PCN 18_0020

AD5671R/75R & AD5675 & AD5672R/76R & AD5676 Timing Specification Changes

This PCN converts data sheet timing specifications that will be changed from the released REV B AD5671R/75R & AD5675 & AD5672R/76R & AD5676 data sheets to the REV C AD5671R/75R & AD5675 & REV D AD5672R/76R & AD5676 data sheets. The old and new specifications are listed in the tables below.

Figure 2. Serial Write Operation

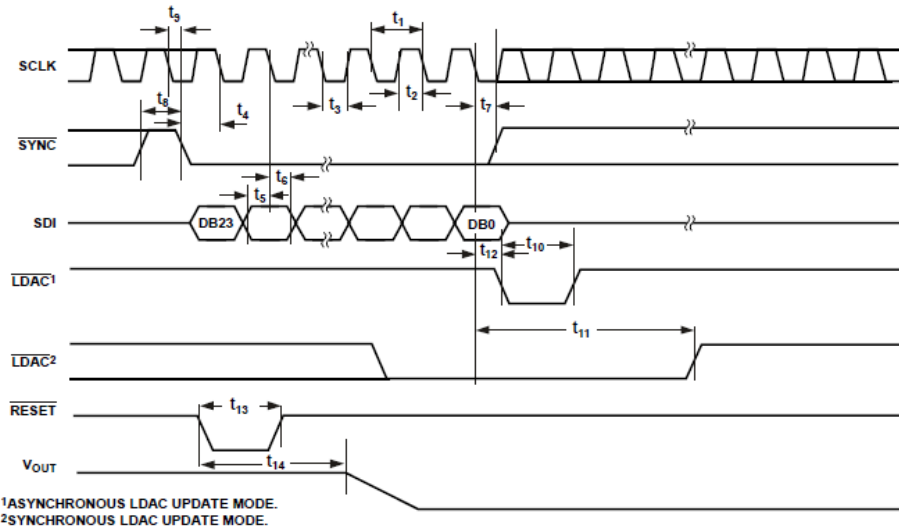
The write timing specifications for the AD5672R/76R and AD5676 Rev. B were:

Parameter	$1.8 \text{ V} \leq V_{LOGIC} < 2.7 \text{ V}$		$2.7 \text{ V} \leq V_{LOGIC} \leq 5.5 \text{ V}$		Unit	Description
	Min	Max	Min	Max		
t_1	20		20		ns	SCLK Cycle Time
t_2	4		1.7		ns	SCLK High Time
t_3	4.5		4.3		ns	SCLK Low Time
t_4	15.1		10.1		ns	$\overline{\text{SYNC}}$ to SCLK Falling Edge Setup Time
t_5	0.8		0.8		ns	Data Setup Time
t_6	0.1		-0.8		ns	Data Hold Time
t_7	0.95		1.25		ns	SCLK Falling Edge to $\overline{\text{SYNC}}$ Rising Edge
t_8	9.65		6.75		ns	Minimum $\overline{\text{SYNC}}$ High Time (Single, Combined, or All Channel Update)
t_9	4.75		9.7		ns	$\overline{\text{SYNC}}$ Falling Edge to SCLK Fall Ignore
t_{10}	4.85		5.45		ns	$\overline{\text{LDAC}}$ Pulse Width Low
t_{11}	41.25		25		ns	SCLK Falling Edge to $\overline{\text{LDAC}}$ Rising Edge
t_{12}	26.35		20.3		ns	SCLK Falling Edge to $\overline{\text{LDAC}}$ Falling Edge
t_{13}	4.8		6.2		ns	$\overline{\text{RESET}}$ Minimum Pulse Width Low

t_{14}	132		80		ns	$\overline{\text{RESET}}$ Pulse Activation Time
	5.15		5.18		μs	Power-Up Time ¹

Figure 2. Serial Write Operation

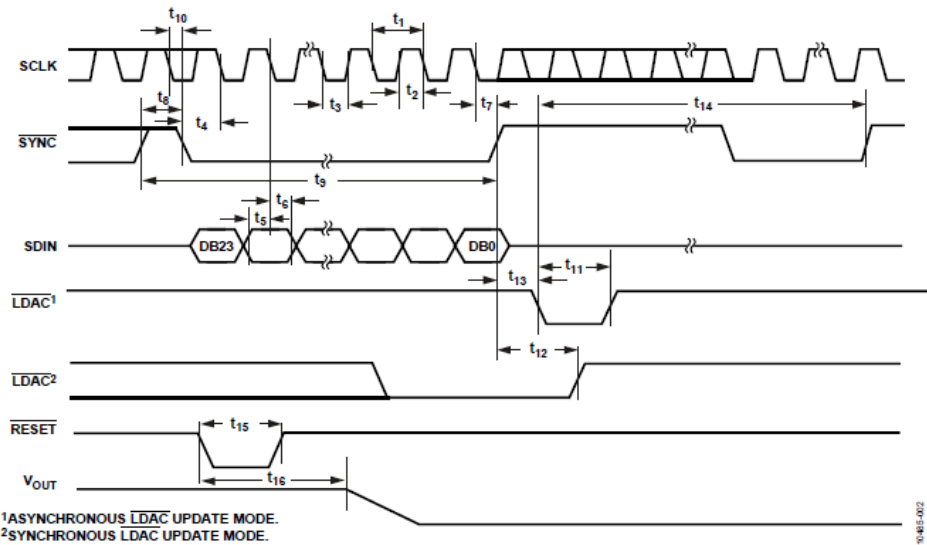
The write timing specifications for the AD5672R/76R and AD5676 Rev. D are:

Parameter	Symbol	1.62 V ≤ V _{LOGIC} < 2.7 V		2.7 V ≤ V _{LOGIC} ≤ 5.5 V		Unit
		Min	Max	Min	Max	
SCLK Cycle Time	t ₁	20		20		ns
SCLK High Time	t ₂	8		8		ns
SCLK Low Time	t ₃	10		12		ns
SYNC to SCLK Falling Edge Setup Time	t ₄	15		11		ns
Data Setup Time	t ₅	2		3		ns
Data Hold Time	t ₆	2		2		ns
SCLK Falling Edge to SYNC Rising Edge	t ₇	4		4		ns
Minimum SYNC High Time	t ₈	15		12		ns
SYNC Rising Edge to SYNC Rising Edge (DAC Register Updates)	t ₉	870		830		ns
SYNC Falling Edge to SCLK Fall Ignore	t ₁₀	4		4		ns
LDAC Pulse Width Low	t ₁₁	8		8		ns
SYNC Rising Edge to LDAC Rising Edge	t ₁₂	25		25		ns
SYNC Rising Edge to LDAC Falling Edge	t ₁₃	25		25		ns
LDAC Falling Edge to SYNC Rising Edge	t ₁₄	840		800		ns
Minimum Pulse Width Low	t ₁₅	8		10		ns
RESET Activation Time	t ₁₆	90		90		ns
Power-Up Time ¹		5.5		5.5		μs

Figure 4. Daisy-Chain Timing Diagram

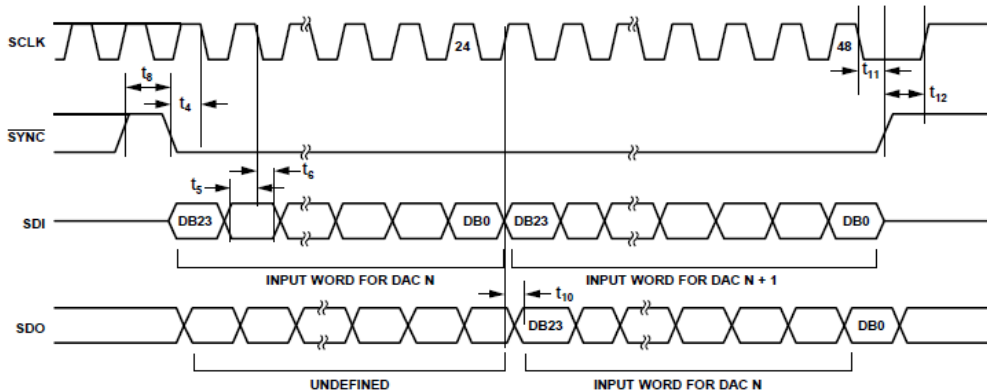
The daisy-chain and readback timing specifications for the AD5672R/76R and AD5676 Rev. B were:

Parameter	1.8 V \leq V _{LOGIC} < 2.7 V		2.7 V \leq V _{LOGIC} \leq 5.5 V		Unit	Description
	Min	Max	Min	Max		
t ₁	120		83.3		ns	SCLK Cycle Time
t ₂	33		25.3		ns	SCLK High Time
t ₃	2.8		3.25		ns	SCLK Low Time
t ₄	75		50		ns	SYNC to SCLK Falling Edge
t ₅	1.2		0.5		ns	Data Setup Time
t ₆	0.3		0.4		ns	Data Hold Time
t ₇	16.2		13		ns	SCLK Falling Edge to SYNC Rising Edge
t ₈	55.1		45		ns	Minimum SYNC High Time
t ₁₀	21.5		22.7		ns	SDO Data Valid from SCLK Rising Edge
t ₁₁	24.4		20.3		ns	SCLK Falling Edge to SYNC Rising Edge
t ₁₂	85.5		54		ns	SYNC Rising Edge to SCLK Rising Edge

Figure 4. Daisy Chain Timing Diagram

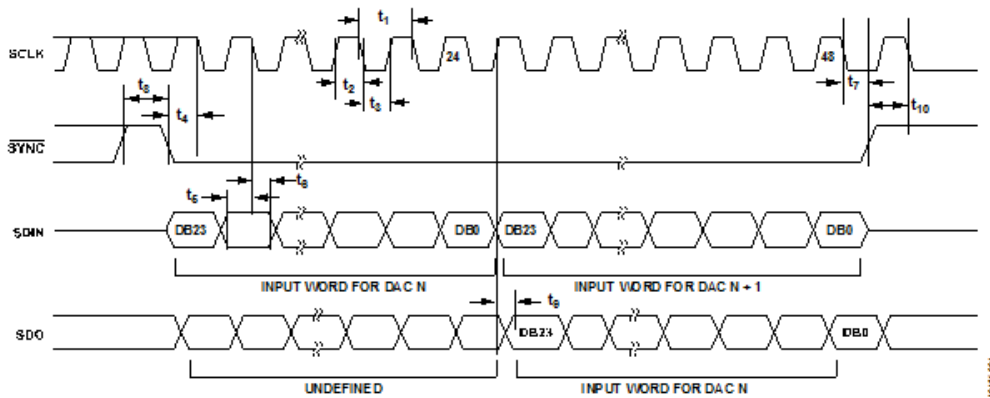
The daisy-chain and readback timing specifications for the AD5672R/76R and AD5676 Rev. D are:

Parameter	Symbol	1.62 V ≤ V _{LOGIC} < 2.7 V		2.7 V ≤ V _{LOGIC} ≤ 5.5 V		Unit
		Min	Max	Min	Max	
SCLK Cycle Time	t ₁	130		110		ns
SCLK High Time	t ₂	33		23		ns
SCLK Low Time	t ₃	12		7		ns
SYNC to SCLK Falling Edge	t ₄	80		80		ns
Data Setup Time	t ₅	2		2		ns
Data Hold Time	t ₆	2		2		ns
SCLK Falling Edge to SYNC Rising Edge	t ₇	35		10		ns
Minimum SYNC High Time	t ₈	55		30		ns
SDO Data Valid from SCLK Rising Edge	t ₉	60		50		ns
SYNC Rising Edge to SCLK Falling Edge	t ₁₀	2		6		ns
SYNC Rising Edge to SDO Disable	t ₁₁	40		35		ns
